**Re: SECTION 4.55(2) MODIFICATION APPLICATION FOR DEVELOPMENT CONSENT NO. D/2022/431**

This letter has been prepared on behalf of QMS Media Pty Limited (QMS) to form part of an application under Section 4.55(2) of the *Environmental Planning and Assessment Act 1979* to modify development consent no. **D/2022/431**, approved on 6 September 2023.

The consent was granted to enable installation of an automated public toilet (APT) on an existing paved area within Sydney Place (at the northern end of Dowling Street), Woolloomooloo.

is satisfied by the submission of the plan titled 'Location Plan – Proposed' issue 07, dated 3 June 2024.

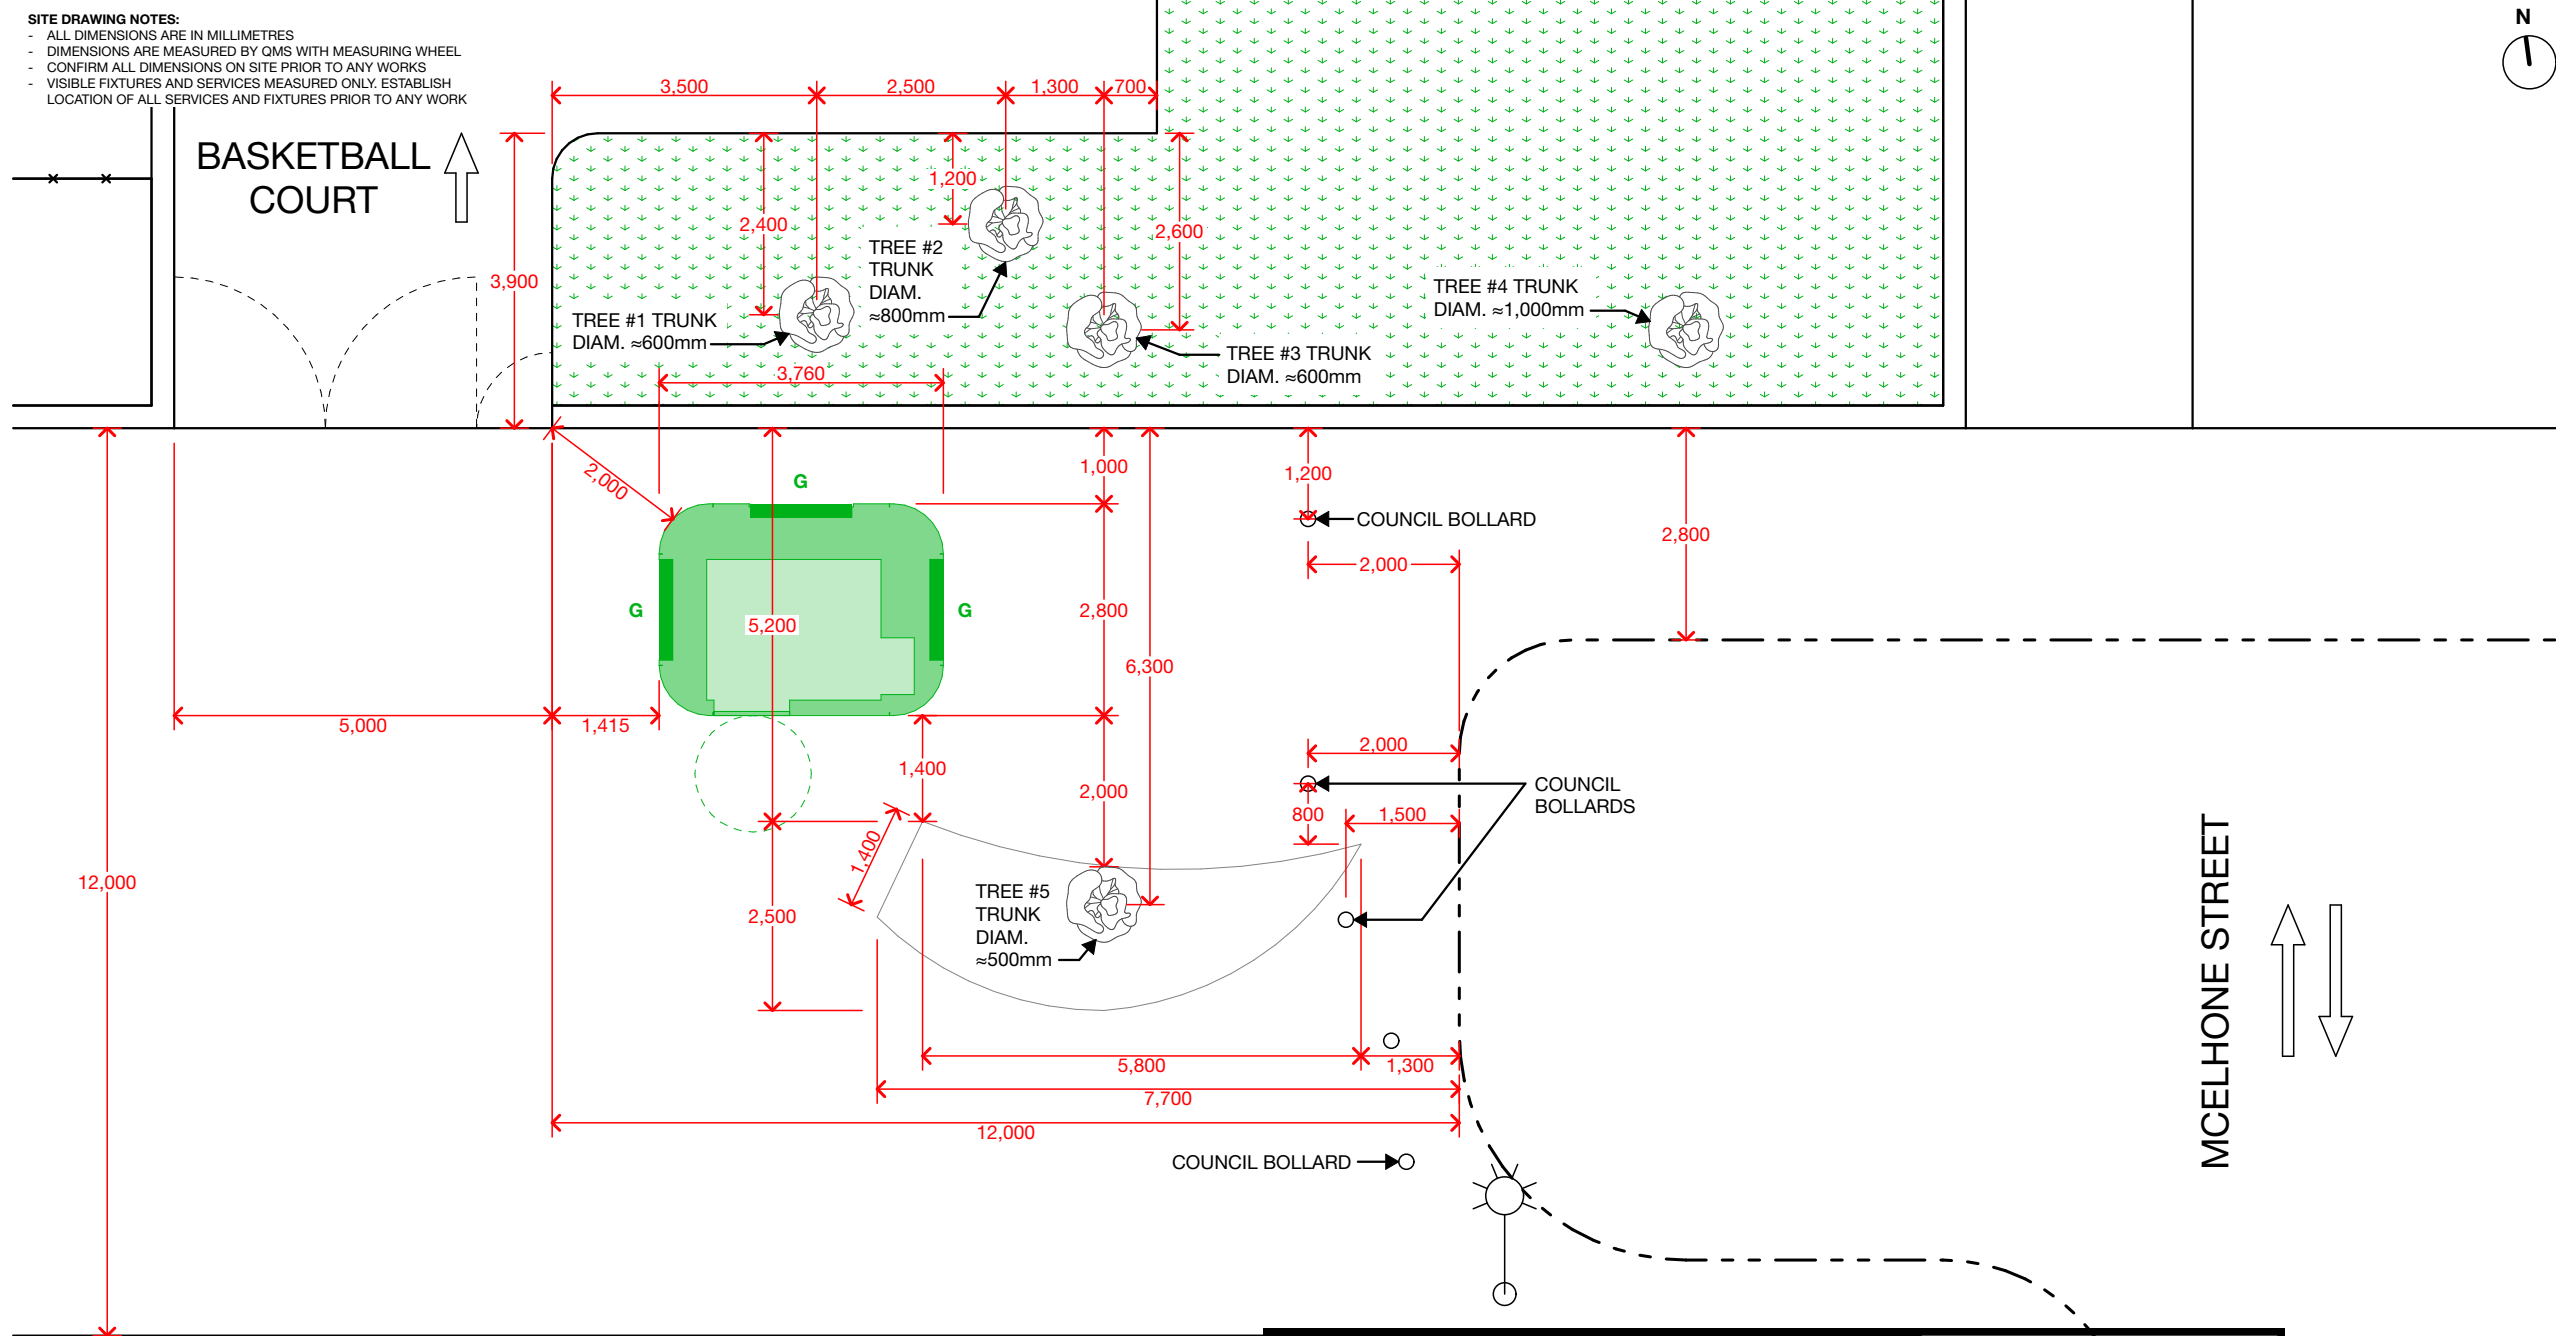
Please be advised that Condition 2 – *Design Modification – APT Relocation*, which reads as follows:

**(2) DESIGN MODIFICATION – APT RELOCATION**

The proposed APT is to be relocated to the eastern side of the basketball court entrance gates on Sydney Place, adjacent to the retaining wall between Sydney Place and the basketball court.

- The distance between the nearest part of the APT and the most eastern side of the basketball court entry gates is to be 2 metres.
- A 1000mm clearance is to be provided between the north rear elevation of the APT and the adjacent retaining wall between the basketball courts and Sydney Place.
